1 P802.11wTM/D2.12
2

22
23
24 Amendment ~~<number>~~ 5 : Protected Management
25 Frames
26
27
28
29
30
31
32

33 *EDITORIAL NOTE - In this redline version of the draft, inserted text is shown as Inserted Text and deleted text is*
34 *shown as Deleted Text.*
35

Figure 8-37—Authenticator state machines, part 1

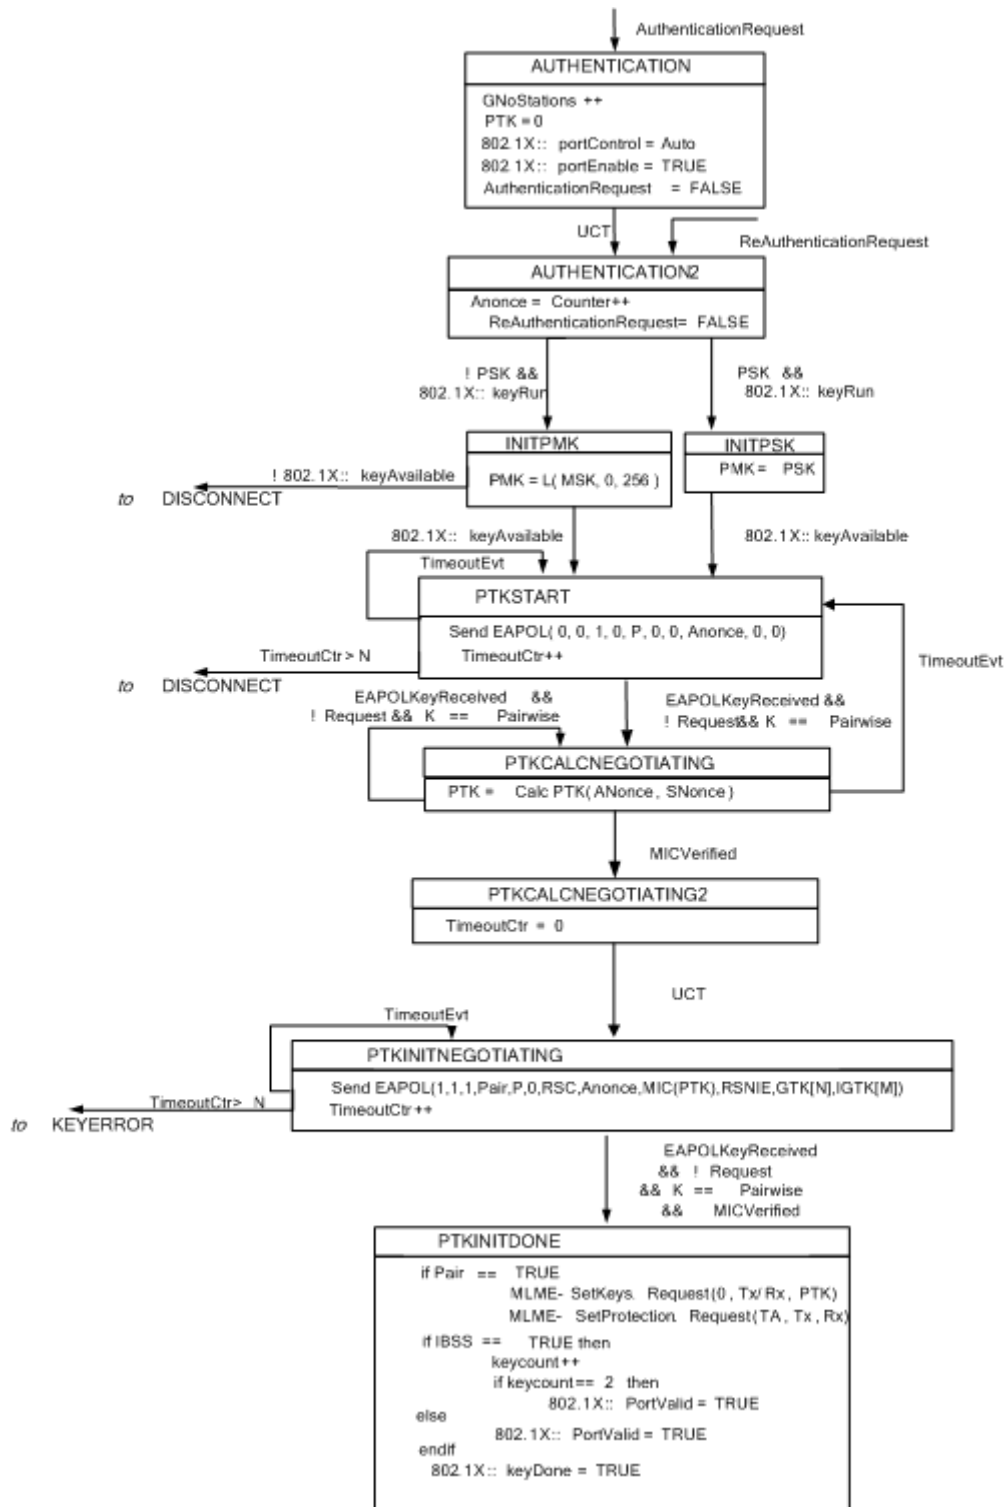
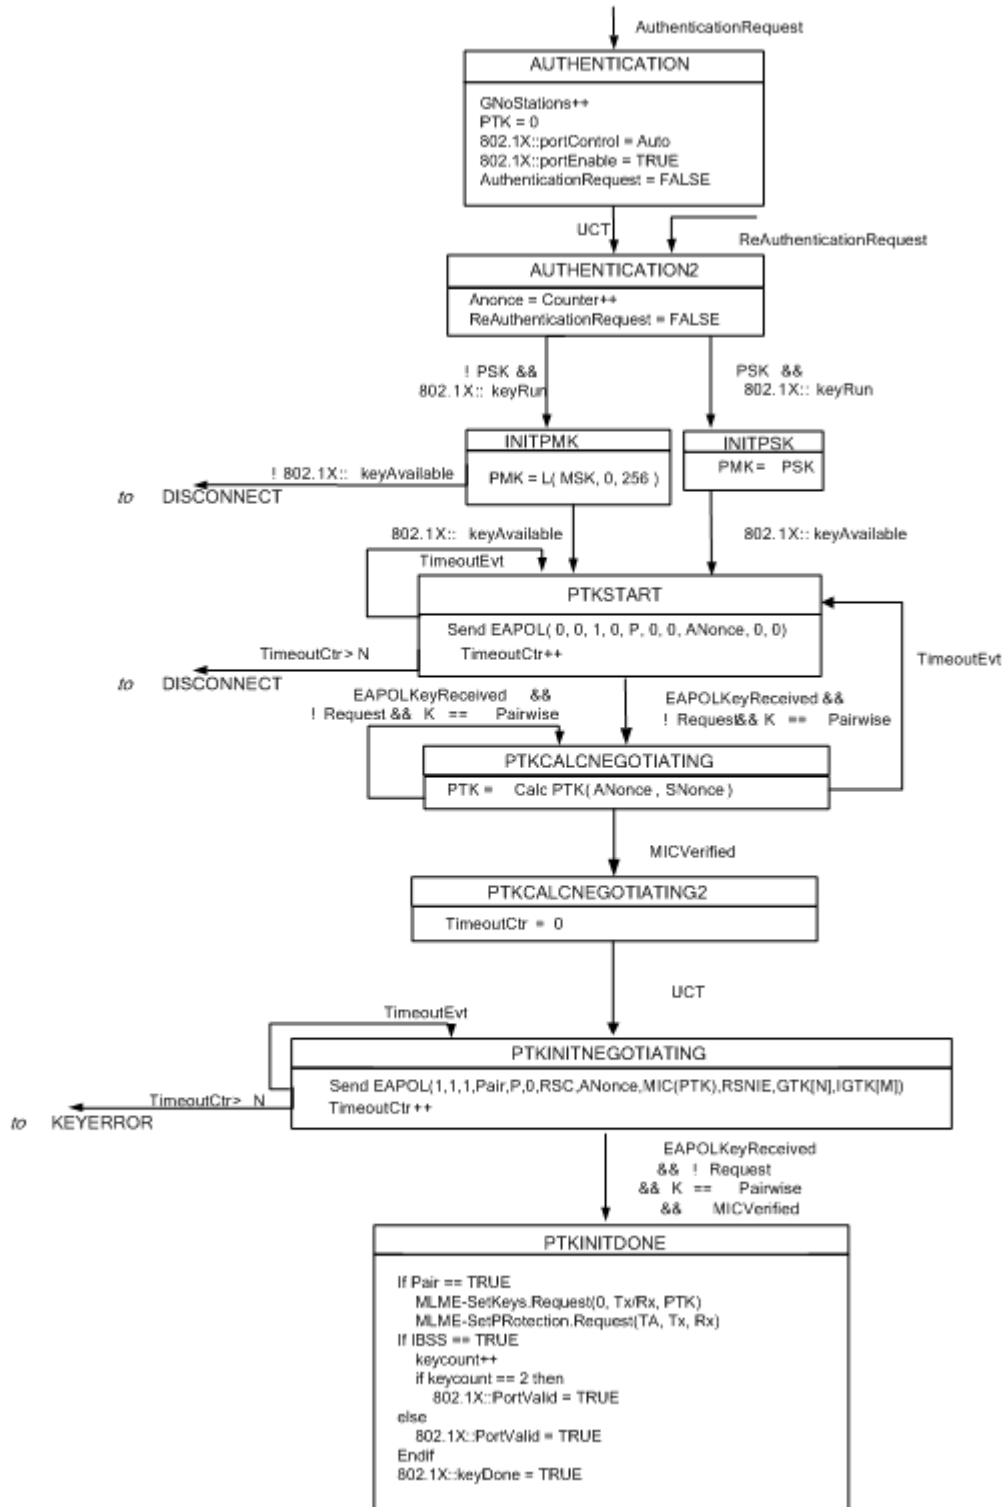
Replace Figure ~~155-8-37~~ with the following Figure, with the updates being fixing Anonce with ANonce in the PTKSTART, PTKCALCNEGOTIATING, and PTKINITNEGOTIATING and the insertion of “IGTK[M]” in the PTKINITNEGOTIATING box:

Figure 8-40—Authenticator state machines, part 4

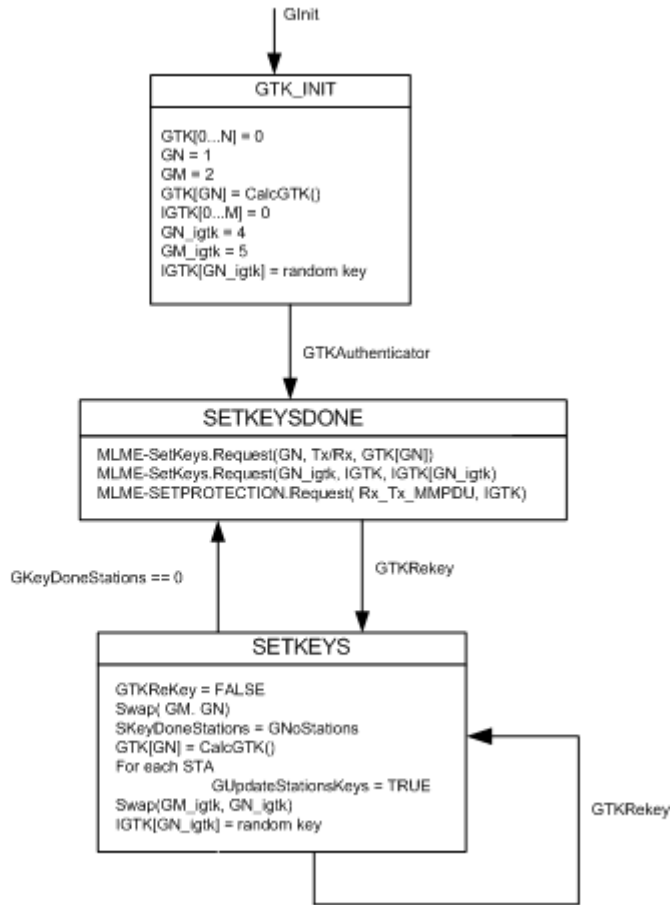
1 **Replace Figure 15.8-40 with the following Figure, with the updates being the addition into the**
 2 **GTK_INIT state (semicolons showing linebreaks): “IGTK[0..M] = 0; GN_igtk = 4; GM_igtk = 5;**
 3 **IGTK[GN_igtk] = random key”;** addition into SETKEYSDONE state: “MLME-SET-
 4 **KEYS.request(GN_igtk, GTK, IGTK[GN_igtk]); MLME-SETPROTECTION.request(Rx_Tx_MMPDU,**
 5 **IGTK)”.** Addition into SETKEYS state: “Swap(GM_igtk, GN_igtk); IGTK[GN_igtk] = random
 6 **key”.insertion of “IGTK[M]” in the PTKINITNEGOTIATING box:**
 7
 8
 9

Figure 11A-13—Authenticator R1KH state machine (part 1)

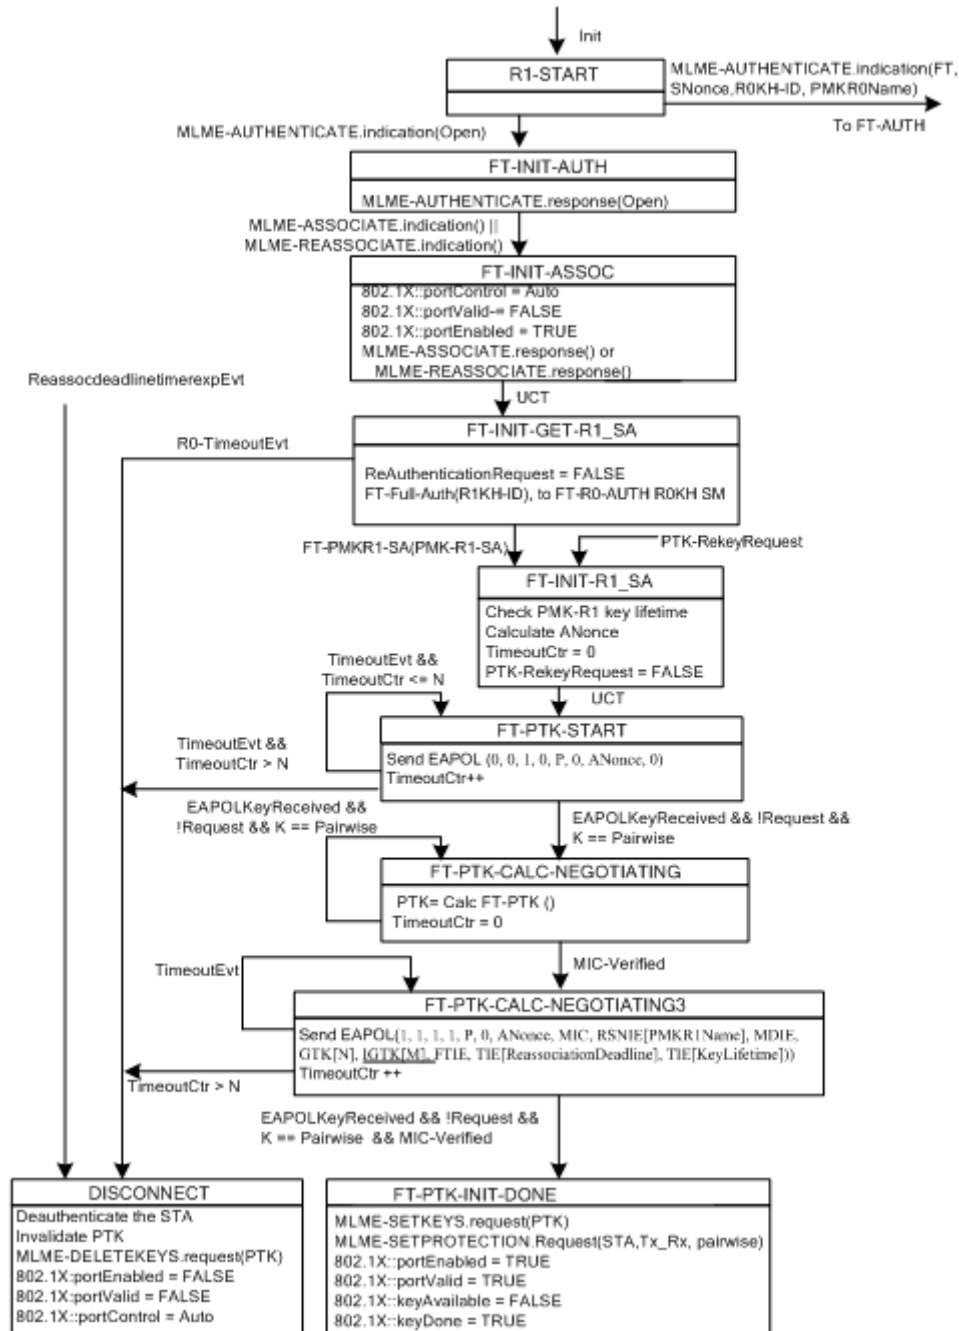
Replace Figure 11A-13 with the following Figure, with the updates being including “IGTK[M]” in the FT-PTK-CALC-NEGOTIATING3 box:

Figure 11A-14—Authenticator R1KH state machine (part 2)

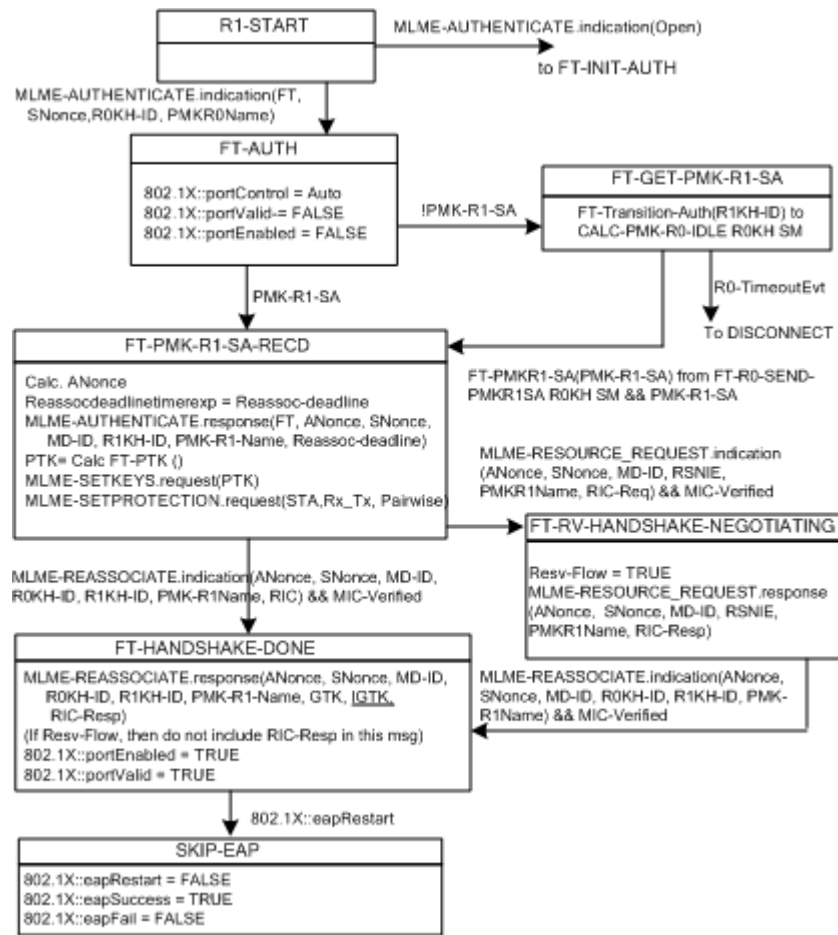
Replace Figure 11A-14 with the following Figure, with the updates being including "IGTK" in the FT-HANDSHAKE-DONE box:
